SERVICE KIT: #52

DATE ISSUED: June 2, 2005 REV C (UPDATED 6-8-05)

SUBJECT: 802 Air Tractor Float Longeron and Float Bracket Repair with longer welded gusset.

MODEL: Floated AT-802 Air Tractors

Figure 1

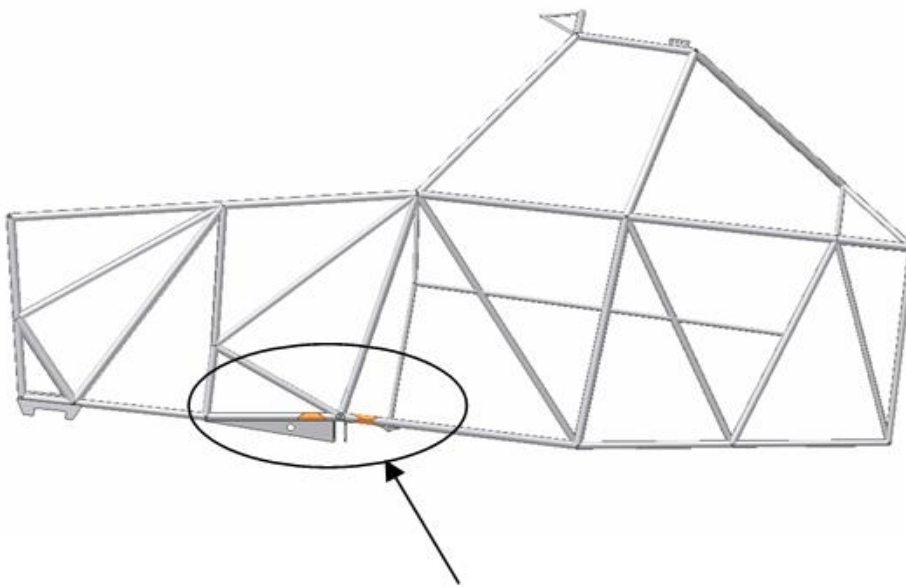
Affected Area

Figure 2

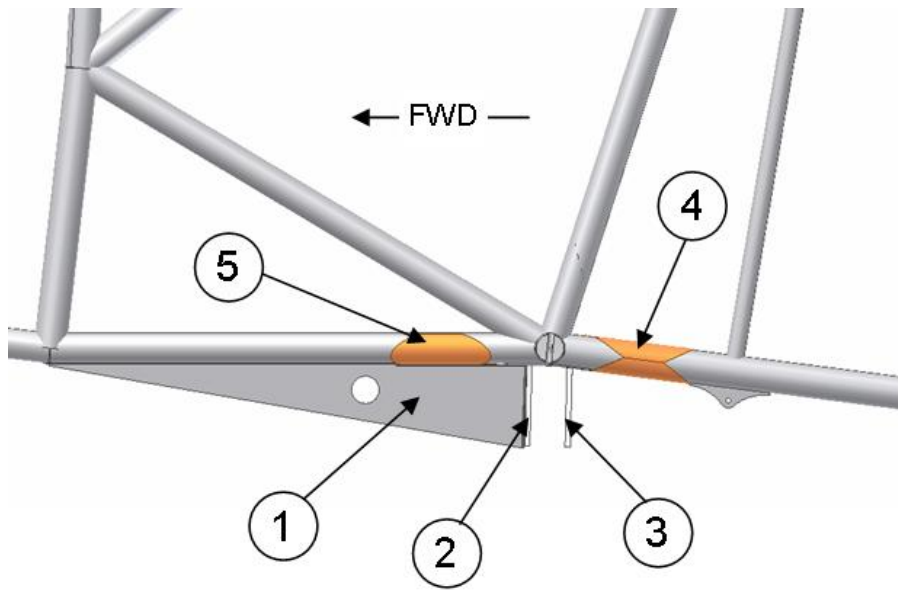
10. Fill fuel tanks or provide other means of safety for welding near fuel tanks.
11. Weld in longer front gusset, as shown in Fig. 2, Area 1 (Wipaire p/n 1001559, Air Tractor p/n SK574-2 or customer fabricated), included with this kit as per Air Tractor instructions included with Service Letter 71 and in compliance with AC 43.13. Use steel spacers in attach plate during welding and stress relieving to retain alignment and shape.

**If sleeve (Figure 2, Item 5) was not installed at the time
Of gusset installation the aircraft may be safely flown
without it. It may be added post fire season.**
